**ZONING AND PLATTING COMMISSION SITE PLAN
CONDITIONAL USE PERMIT REVIEW SHEET**

CASE NUMBER: SPC-2016-0287C **ZAP COMMISSION:** March 21, 2017

PROJECT NAME: Austin Onion Creek Fire and EMS Station

CITY OF AUSTIN – DEVELOPMENT SERVICES DEPARTMENT
SITE PLAN APPLICATION – MASTER COMMENT REPORT

SITE PLAN
SHEET 5 OF 35
C2.0

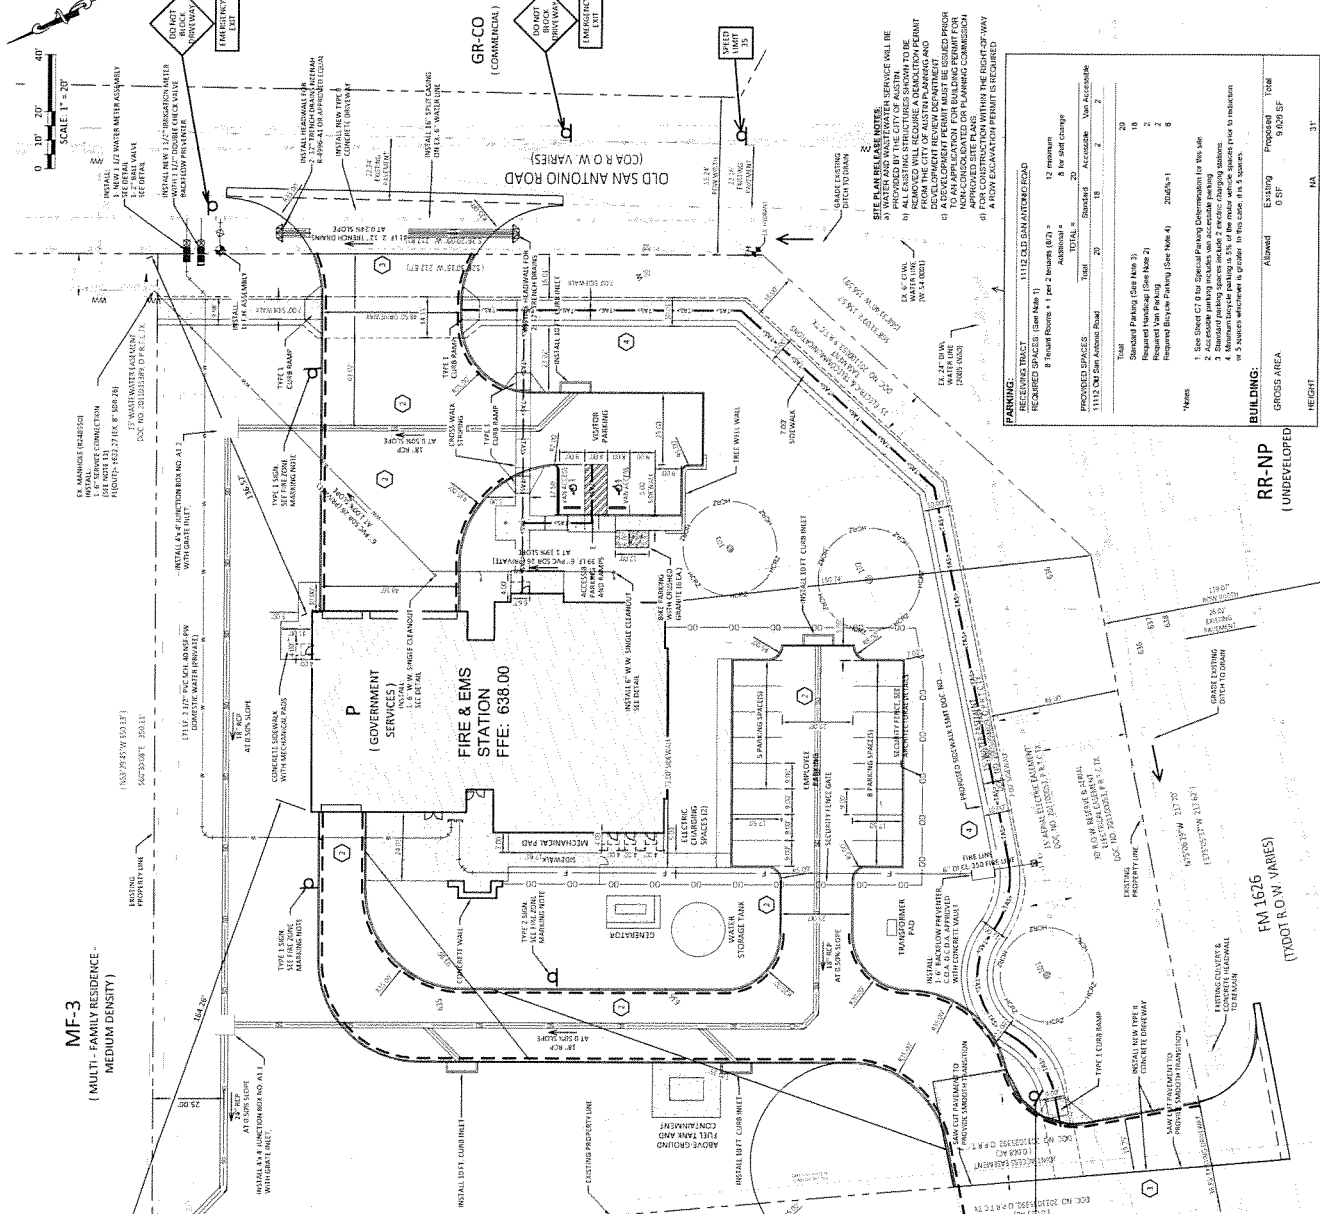
TR6. ***U3: Comment cleared; AEC approved to flip the clear and planting zones due to existing electric easements – applicant will now proposed an enlarged 7 foot clear zone and a 8 foot planting zone.***

TR7. Where required, the sidewalk shall extend onto private property to fulfill the 12-foot minimum requirement, with a sidewalk easement provided (§2.2.4.B, §2.2.3.B). Provide an additional two feet within the easement for maintenance purposes. TCM, 4.2.1, 4.2.2.
U1: Comment PENDING; please provide Design Commission AEC documentation. Please provide the sidewalk easement for review.
U2: Comment not cleared; additional information is needed, as the Design Commission does not grant AEC waivers, nor were any previously approved AEC information provided to this reviewer.
U3: Comment not cleared.

TR27. Trash dumpsters must be located to provide adequate access and maneuverability for service vehicles. Show the dumpster. LDC, 25-2-1067(c); TCM, 9.3.0.2.

U3: Comment not cleared; AEC letter has been approved – please add this to the site plan sheet.
